CHARLOTTE - MECKLENBURG
PLANNING COMMISSION

SUBJECT: Administrative Approval for Petition No. 97-62 Educational Facilities Group, Inc.

EDUCATIONAL FACILITIES GROUP

TECHNICAL
DATA SHEET
ATTACHED TO ADMINISTRATIVE
APPROVAL
PETITION NO. 97-62
AS FOR PUBLIC HEARING
DATED: August 2, 2002
BY: MARTIN R. CRAMTON, JR. *Martin R. Cramton, Jr.*

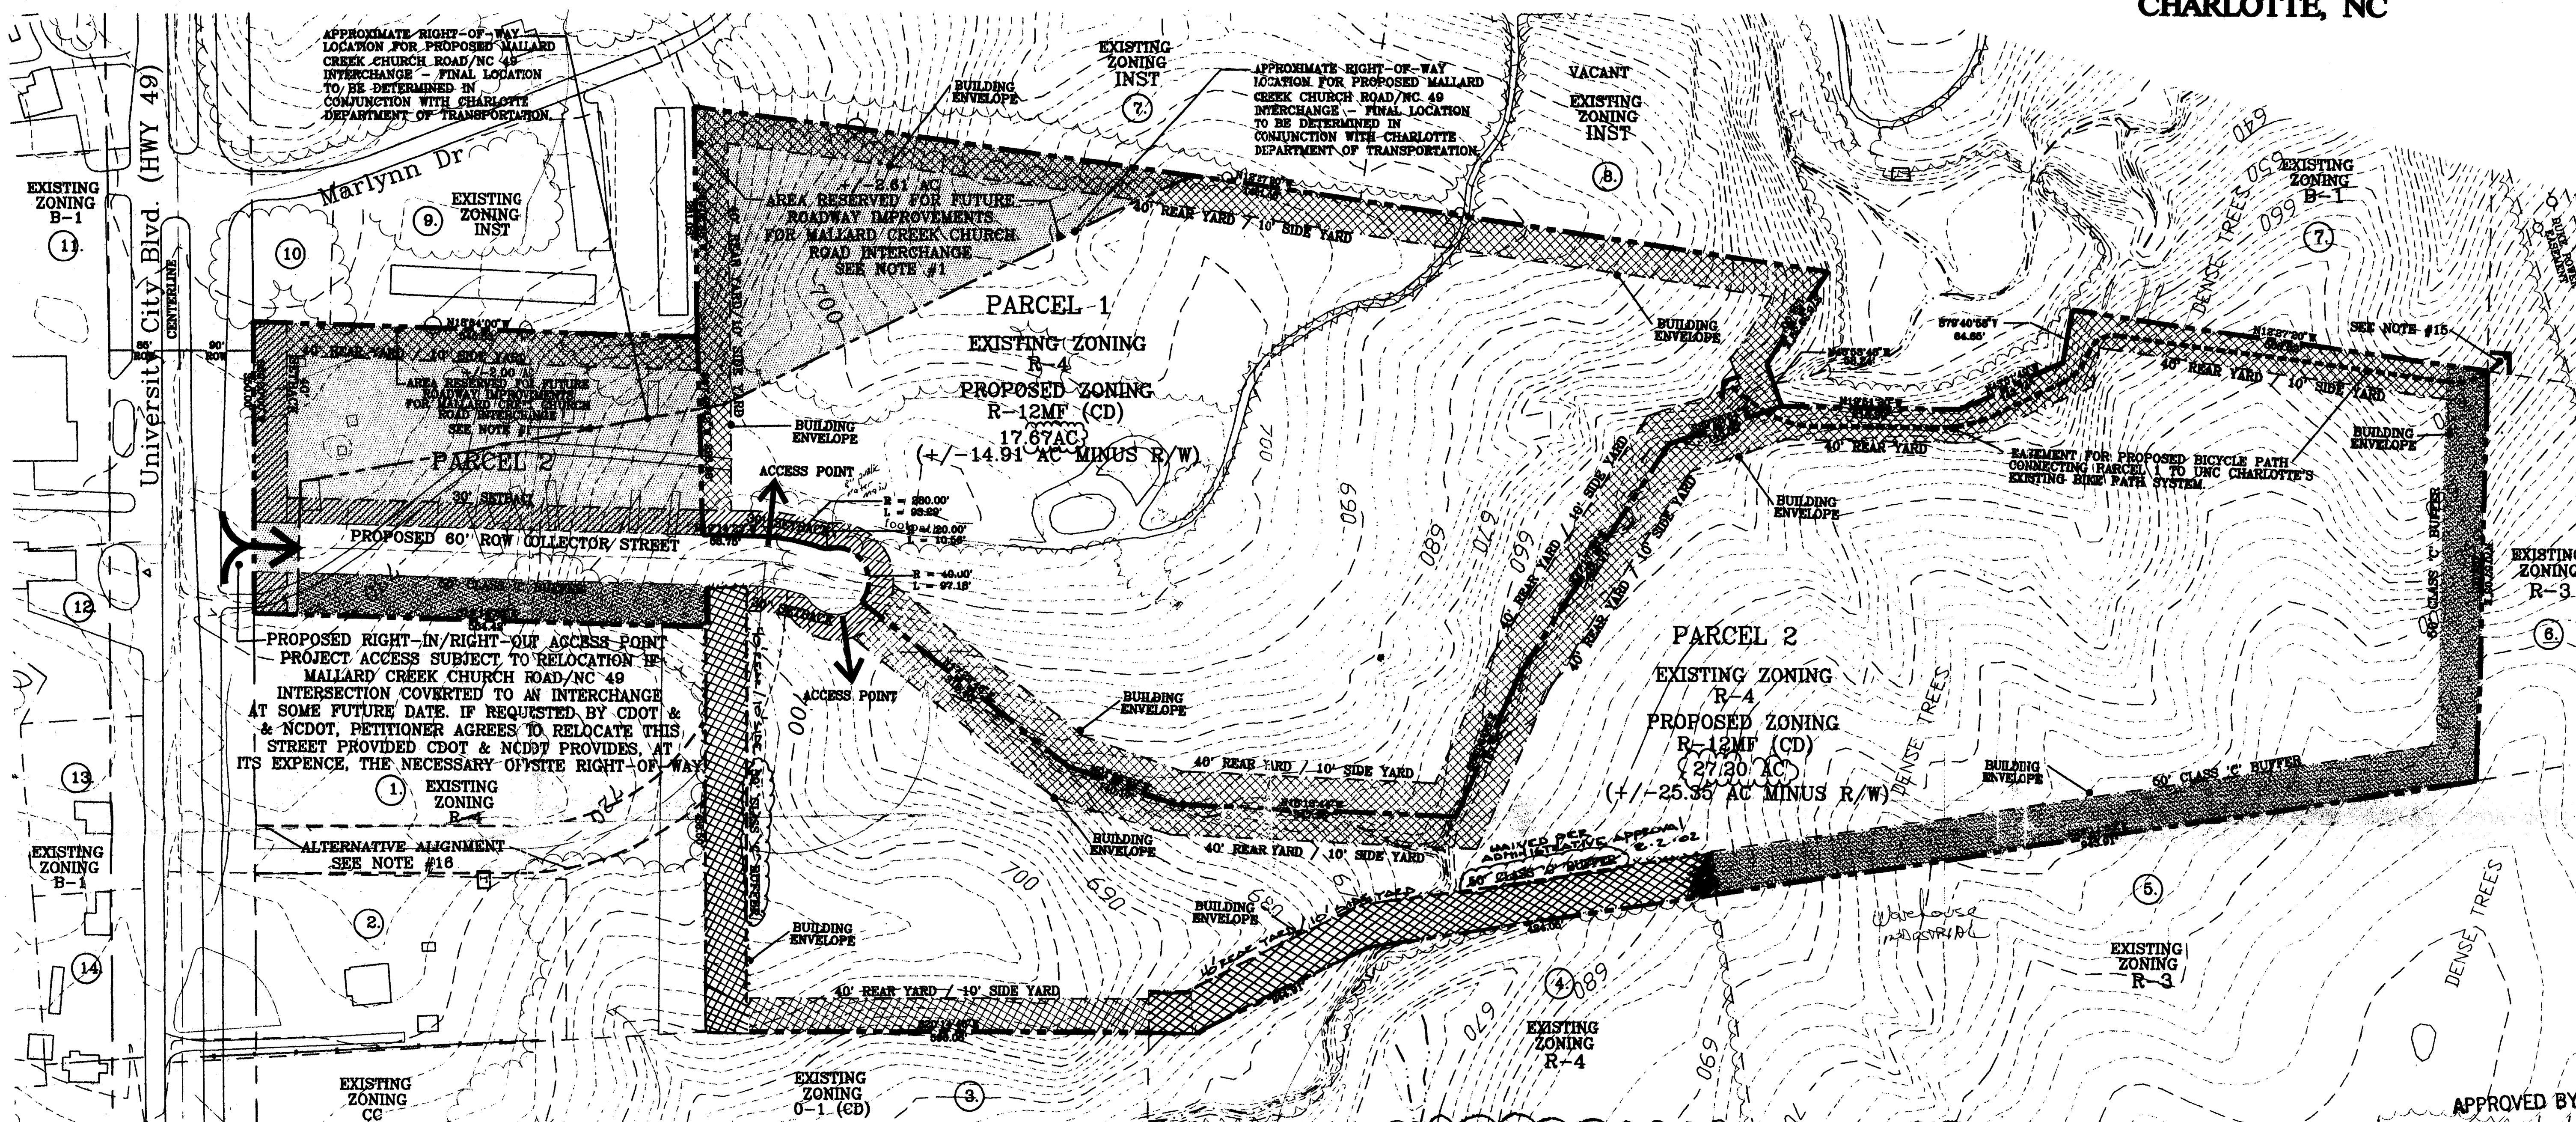
Attached is the revised plan for the above petition. The plan has been revised to show the elimination of portions of the buffer due to the rezoning of adjoining property and use changes on adjoining property. Since these changes do not alter the intent of the development and meets the requirements of the Charlotte Zoning Ordinance Section 6.206(2) Alterations to Approval for minor changes, I am administratively approving this plan. Please use this plan when evaluating requests for building permits and certificates of occupancy.

18. As depicted on this site plan, certain portions of the previously required Class "C" Buffer within Parcel 2 have been eliminated based on an Administrative Approval authorized by the Charlotte-Mecklenburg Planning Commission on August 2, 2002.

- This Administrative Approval was authorized based on an analysis of certain changes that have occurred on adjacent properties that will satisfy buffer requirements in these areas along common property boundaries abutting the subject site. These changes are a result of development approvals or development activity that have occurred on adjacent properties since the effective date of when this petition (897-62) was approved on 9.15.97.
